**Mercer Hill
Area Structure Plan**

**RE: MERCER HILL AREA STRUCTURE PLAN
PART OF THE EAST ½ SECTION 2-73-6-W6M
PREPARED BY BEAIRSTO LEHNERS KETCHUM ENGINEERING LTD.**

**RE: REVISED MERCER HILL AREA STRUCTURE PLAN
PART OF THE EAST ½ SECTION 2-73-6-W6M
PREPARED BY BEAIRSTO LEHNERS KETCHUM ENGINEERING LTD.**

Map 5A - Transportation Network
April 2009

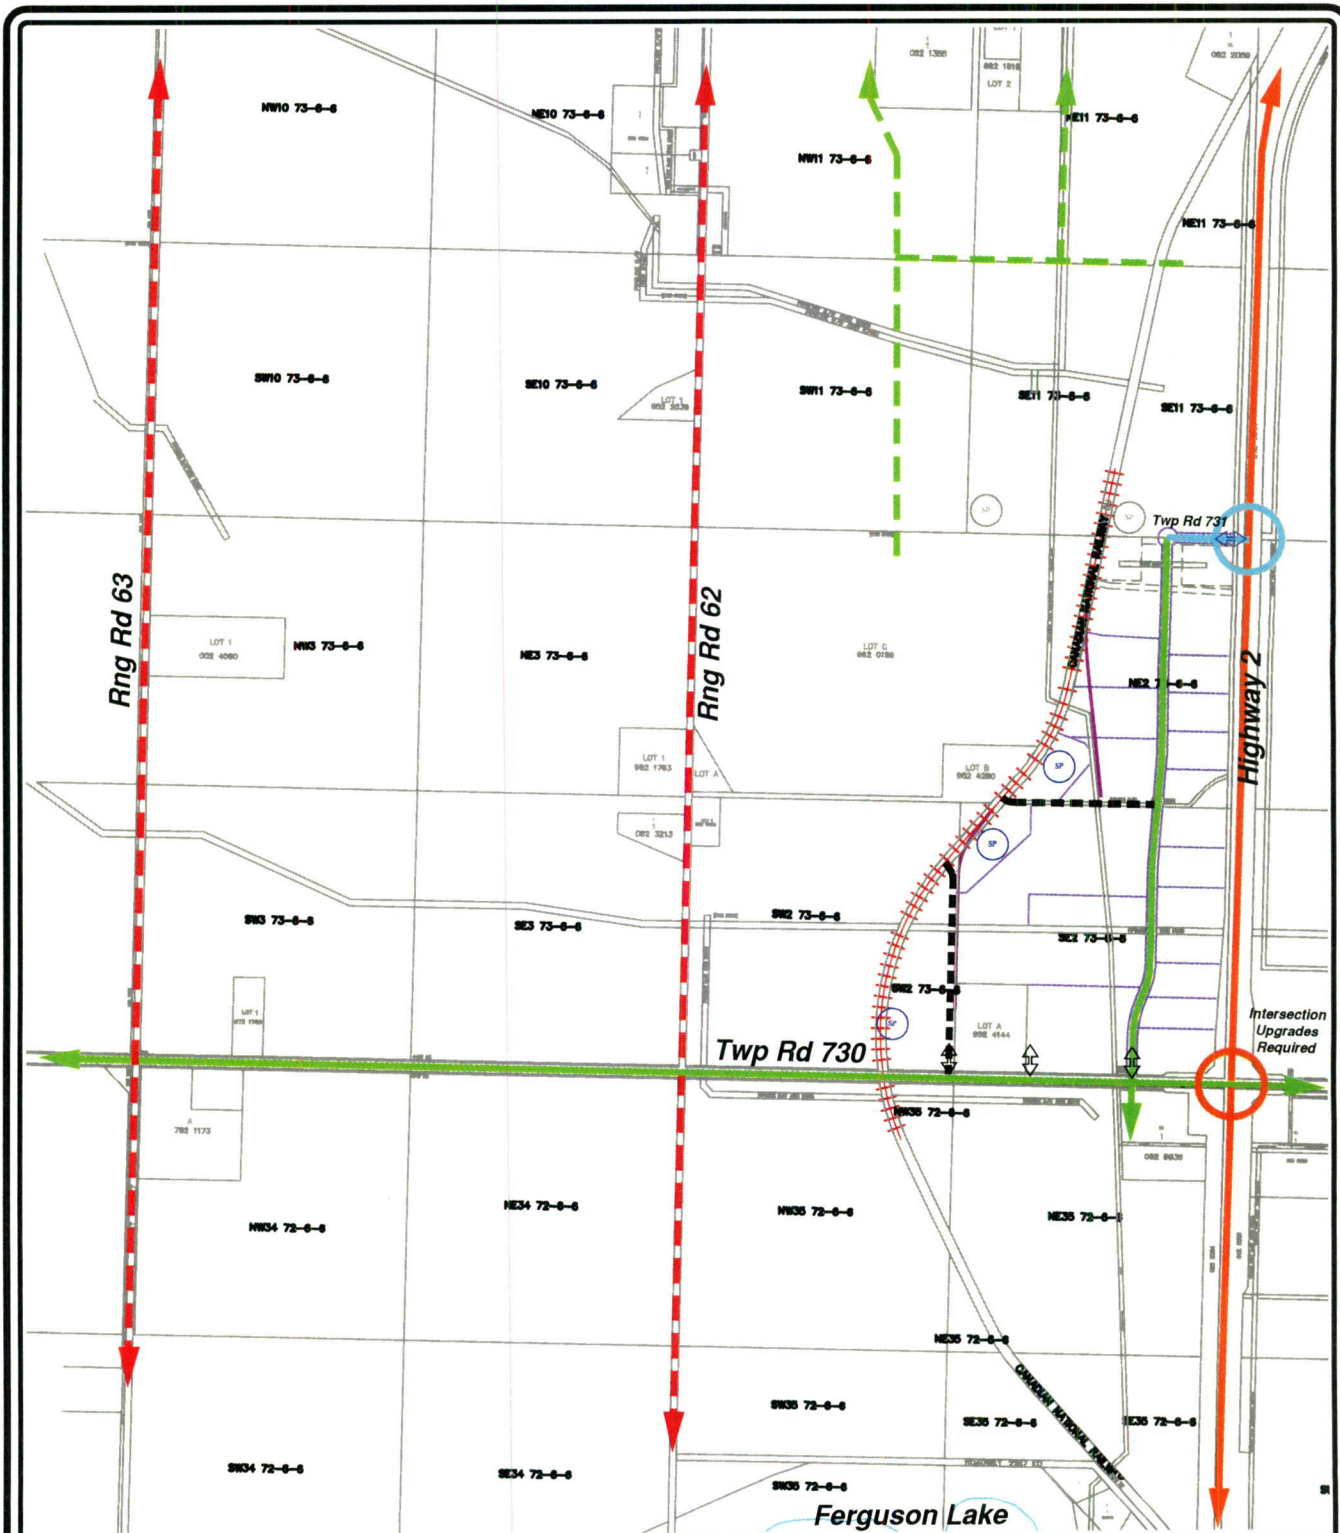
- Transportation network maps 5A and 5B note the highway intersection at Township Road 730, however they do not indicate that specific intersection improvements are required.
- Transportation network maps 5A and 5B note that Township Road 730 would be paved in the future to promote traffic movement to the west. Within the Transportation and Servicing section the ASP needs to provide additional detail as to future for Township Road 730.
- Within Section 3.4 (Storm Water Management) the statement "The ponds will be sized to accommodate each basin as identified in Map 8, to allow discharge to continue east at pre-development rates ..." seems to be contradictory to other information presented in the ASP which indicates that storm water in the plan area would travel generally from east to west.
